# PMA+PMD Delay of an Optical Module

Jeffery Maki  
Juniper Networks

# Comment #82

Figure 173-2—Examples of 800GBASE-R PMA layering

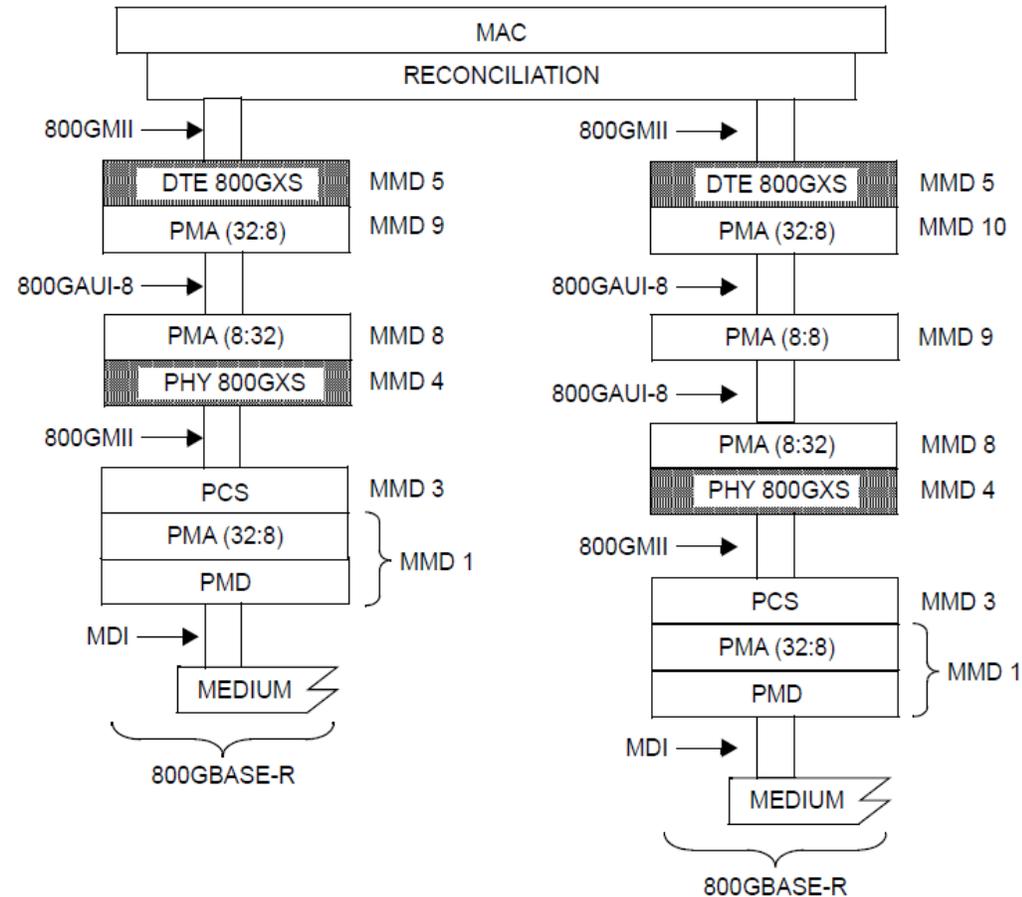
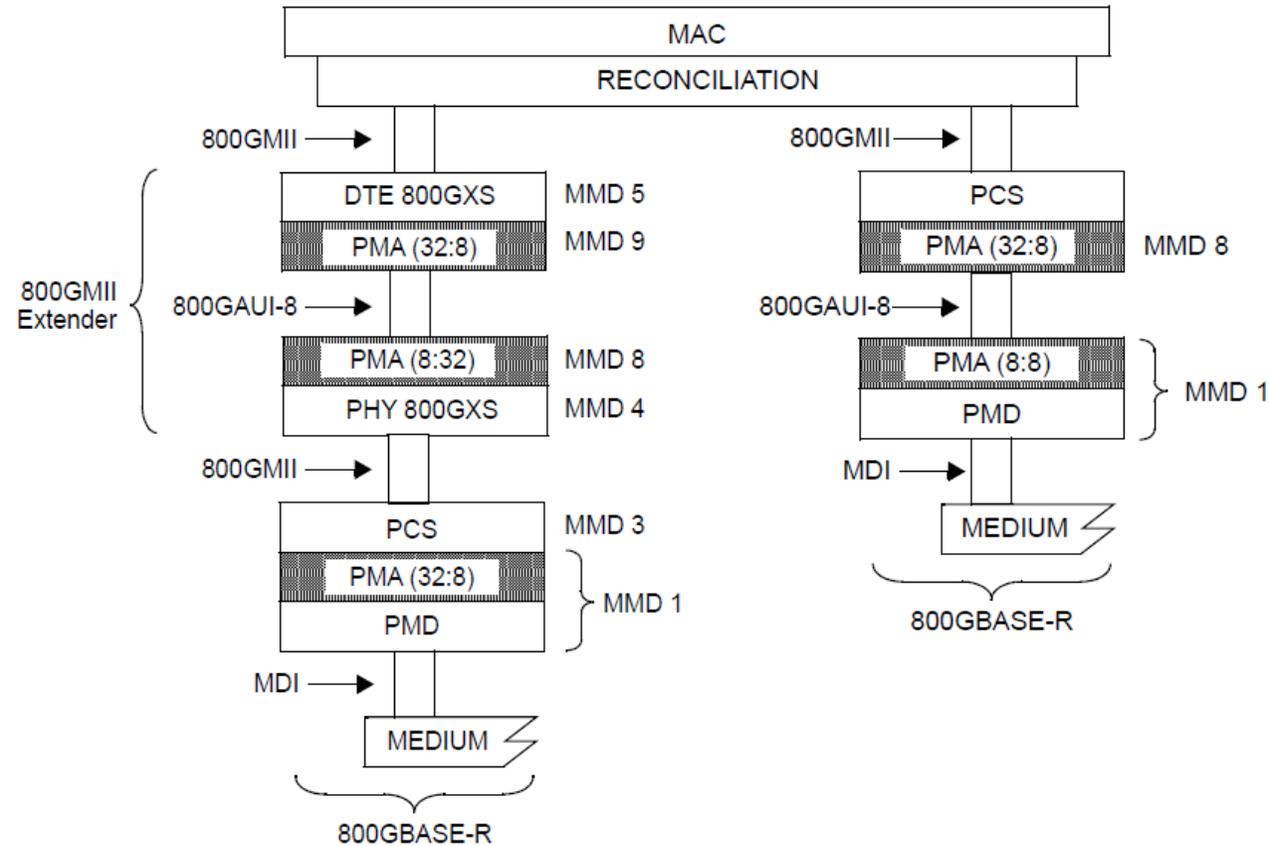
The sum of the sublayer delays of 92.16 ns for 800GBASE-R PMA (up to four PMA stages) and 20.48 ns for 800GBASE-VR8/SR8/DR8/DR8-2 PMD is 112.64 ns, which is less than the observed delay of two PMA stages and the PMD. The concern is that these sublayers delays are specified too small in value to be feasible. Excessive delays of about 50% are seen for optical modules (two PMA stages + PMD).

The maximum cumulative delay contributed by up to **four PMA stages** in a PHY (sum of transmit and receive delays at one end of the link) shall meet the values specified in Figure 173–1. A description of overall system delay constraints and the definitions for bit-times and pause\_quanta can be found in 169.4 and its references.

- For the PMA Stage that appears next to the PMD, specify the sum PMA+PMD
- Leave a separate budget for the other PMA Stages
- Use a value of **200 ns** providing plenty of implementation variation for all cases where the PMD is optical
  - 800GBASE-VR8
  - 800GBASE-SR8
  - 800GBASE-DR8
  - 800GBASE-DR8-2

The specification of delay for the PMA is rather ambiguous and the delay specified for the PMA and PMD may be smaller than necessary to permit practical implementations. However, a complete proposal with appropriate background and specific changes to the draft is required.
